OUTLINE FOR COMPENSATORY MEASURES HEAVY LOAD DROP PROTECTION

TENNESSEE VALLEY AUTHORITY
SEQUOYAH NUCLEAR PLANT (SQN)
UNIT 1
DOCKET NO. 327

SEQUOYAH NUCLEAR PLANT (SQN) - STEAM GENERATOR REPLACEMENT
PROJECT - TOPICAL REPORT NO. 24370-TR-C-002, "RIGGING AND
HEAVY LOAD HANDLING TOPICAL REPORT," ADDITIONAL INFORMATION

Reference: TVA letter to NRC dated January 15, 2002,
"Sequoyah Nuclear Plant (SQN) - Steam Generator
Replacement Project - Topical Report No. 24370-
TR-C-002, "Rigging and Heavy Load Handling
Topical Report," Response to NRC Request for
Additional Information

Figure 2 - GT Strudl Model of PTC Crane - Enlargement of Crane Base

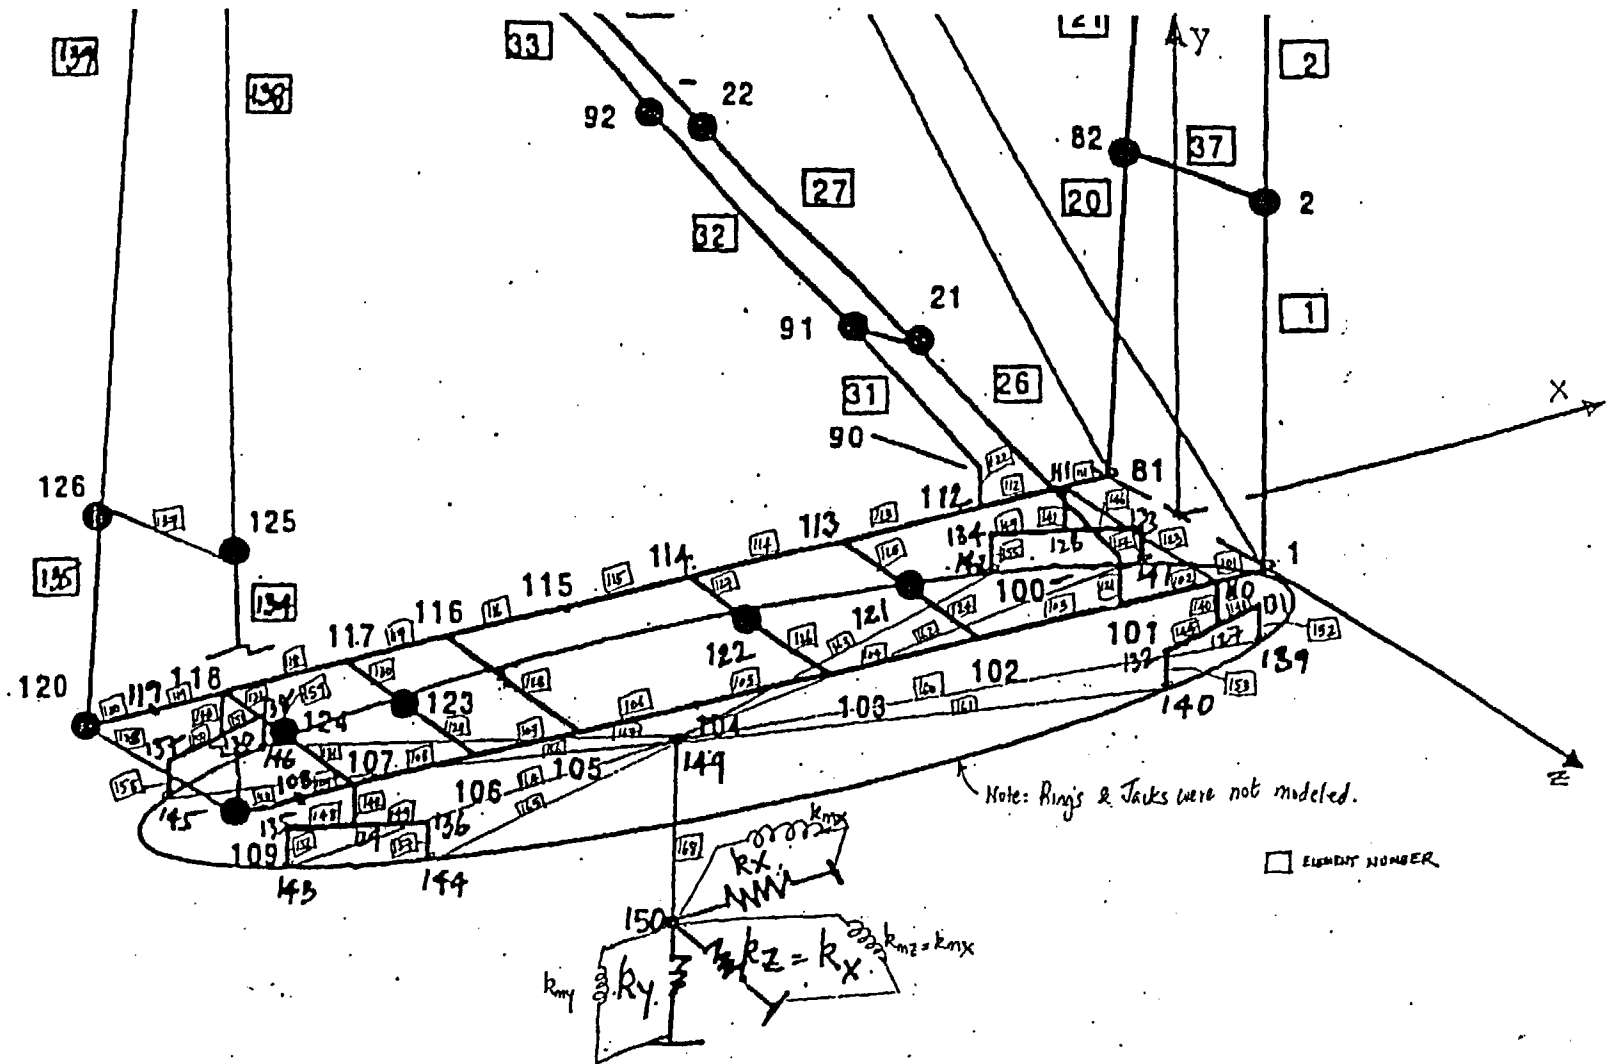
The maximum lifted load of the generators during the SGRP is approximately 386 mt (metric tonnes). The maximum lift radius with the full SG load is 54.84 m. The rated chart capacity (including effect of allowable operating wind speed) of the OLS based on a 55 m lift radius is 408 mt. The worse case lifted load is therefore 94.3% of chart capacity. It is noted that this 94.3% chart capacity happens only for one of the Replacement Steam Generators (RSGs). For the other RSGs and the OSGs, the percentage of chart capacity at their maximum lift radii are around 91% or less. Further, the OLS is seated on a firm engineered pile foundation that is adequately designed for the design loads including seismic SSE loads obtained from the finite element analysis, ensuring that there will not be a collapse of the OLS due to a foundation failure in a seismic event.

The evaluation thus demonstrated that the OLS will remain structurally adequate and stable and will not collapse or result in a drop of the load during a design basis SSE event for the lift configurations to be used for the Sequoyah Unit 1 SGRP. Therefore, use of the OLS for the Sequoyah Unit 1 SGRP will not result in any seismic II/I interaction issues on the Category 1 SSCs located in the vicinity of the OLS.

Comparison Table
PTC versus PRHD Crane

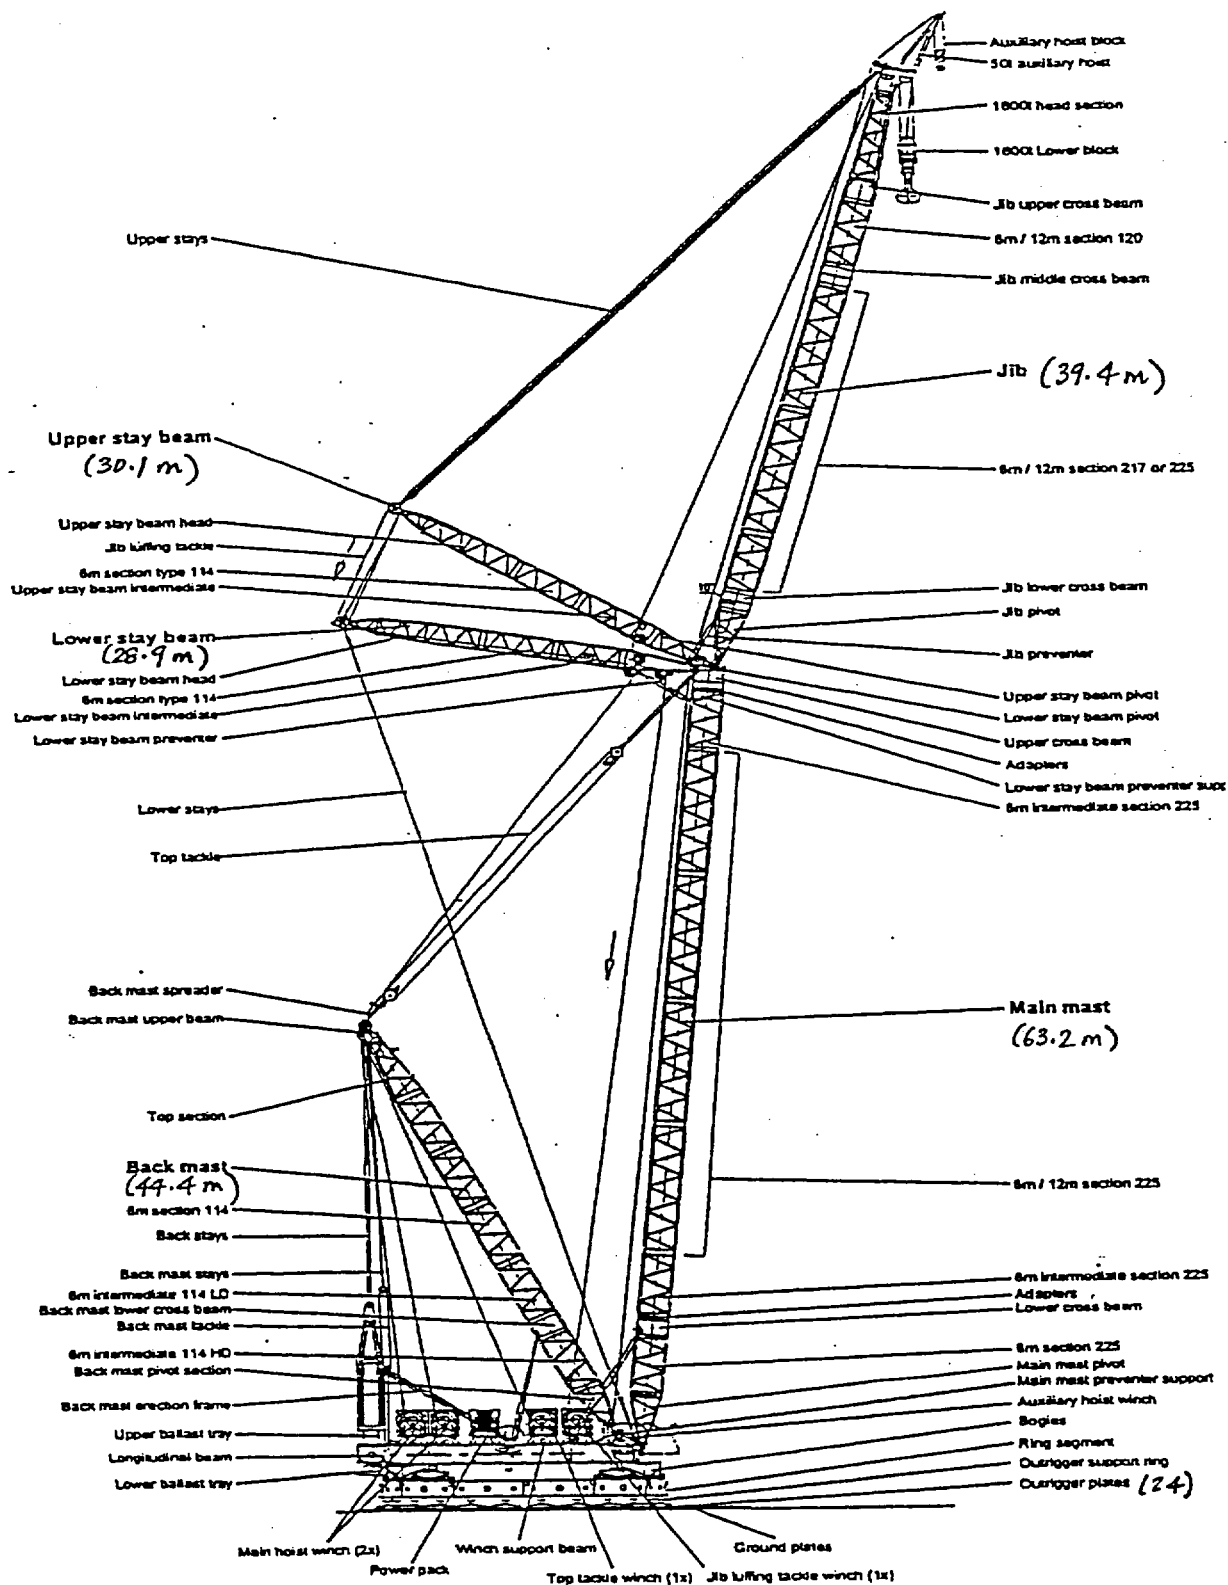
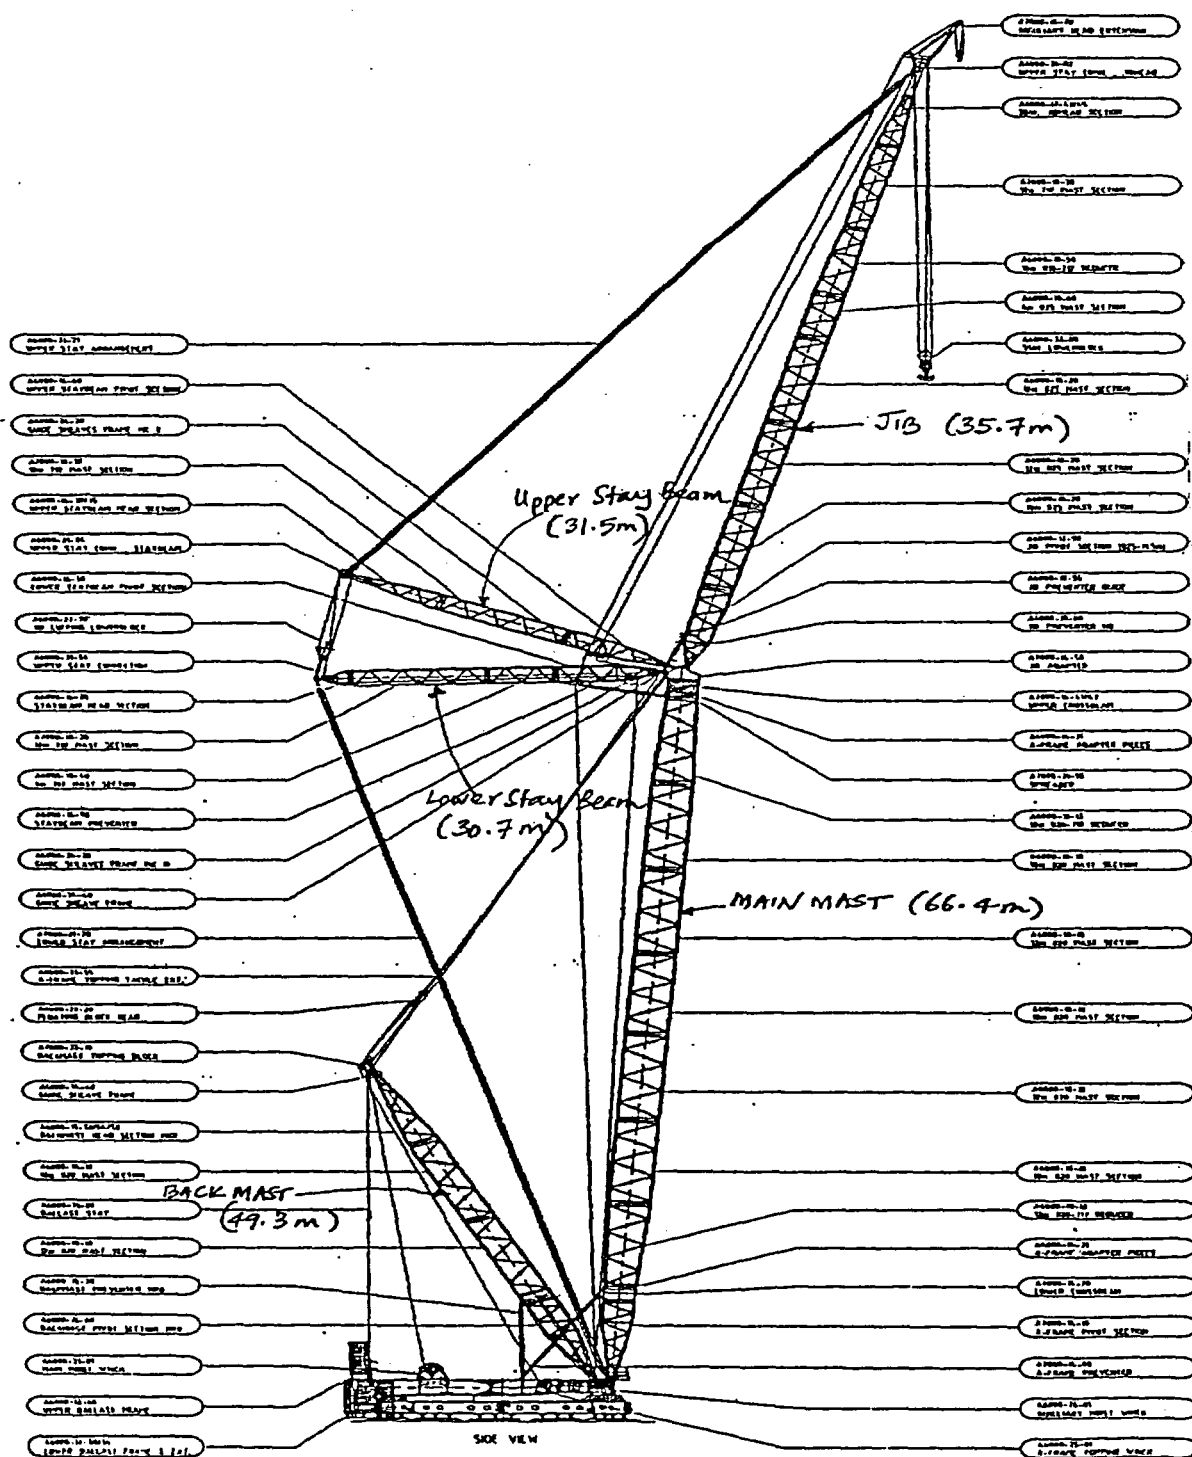
Topical Report 24370-TR-C-002, Section 5.1, describes the Outside Lift System (OLS) crane to be used for handling heavy loads during the steam generator replacement at Sequoyah Unit 1. Responses to NRC requests for additional information (RAIs) provided further details of the OLS. The crane to be used as the OLS will be one of two that are owned by the crane supplier. They are the Platform Twin-Ring Containerized (PTC) Heavy Lift Crane (see Figure 1) upon which the Topical Report was based, and the Platform Ring Heavy Duty (PRHD) Crane (see Figure 2). Recent developments in the usage schedule for the PTC may require the use of the PRHD crane instead of the PTC crane. The PRHD crane is a similarly configured crane and is the predecessor to the PTC crane. Therefore, its features are generally the same.

The standout feature of the PTC crane is that it is containerized. This means that it is easily transportable as standard containers of 20 or 40 ft length weighing no more than 35 tons. If used, the PTC crane would arrive in approximately 90 standard container-sized pieces. The PRHD crane is not as easy to transport as the PTC. The PRHD crane would arrive in approximately 140 pieces, not all of which are standard container-sized. The containerized feature of the PTC crane facilitates easy transport without any special requirements and is the most significant difference from the PRHD crane. However, this difference has no impact on the crane's ability to perform heavy load handling operations for the Sequoyah Unit 1 Steam Generator Replacement Project.

To evaluate and document the acceptability of the PRHD crane, a comparison of PTC crane attributes (detailed in Topical Report 24370-TR-C-002 and RAI responses) to the corresponding PRHD crane attributes is provided in the following table. Elevation views of the PTC and PRHD cranes are also provided as Figures 1 and 2, respectively. Two comparison bases are used to demonstrate similarity of the cranes: (1) direct comparison of the physical attributes; and (2) evaluation of the PRHD dynamic response characteristics under SSE for one of the critical configurations. Based on the comparison of the two cranes, it is shown that the conclusions of Topical Report 24370-TR-C-002 remain unchanged in that the attributes of the PRHD crane meet or exceed those of the PTC crane.

Crane Attribute	Description	PTC Crane	PRHD Crane	Remarks/Basis for Acceptability of PRHD Crane
	<p>disassembly will be performed in accordance with the crane manufacturer's procedures and drawings. (RAI 12.(b), TR Sects. 4.2, 5.1)</p> <ul style="list-style-type: none"> Main boom assembly (TR Sect. 5.1) 	<p>Assembly of the main boom will be performed in an area to the north of the Unit 1 Containment as shown on Figure 5-2 of Topical Report 24370-TR-C-002.</p>	<p>Assembly of main boom will start to the west of the position shown on Figure 5-2 of Topical Report 24370-TR-C-002 (as shown on Figure 3), which places the boom in a northerly direction from the crane base. This will allow assembly of the main boom on the ground without interfering with the RWST structure. The main boom will be attached to the base of the crane and moved to the position shown on Figure 5-2 of Topical Report 24370-TR-C-002 for erection of the jib and stay beams.</p>	<p>Assembly process is the same. If initial assembly occurred as shown in the topical report, it would have to occur off the ground to clear an interference with the RWST retaining wall. Controls for erection cranes and protection of underground equipment are the same. Therefore, no impact.</p>
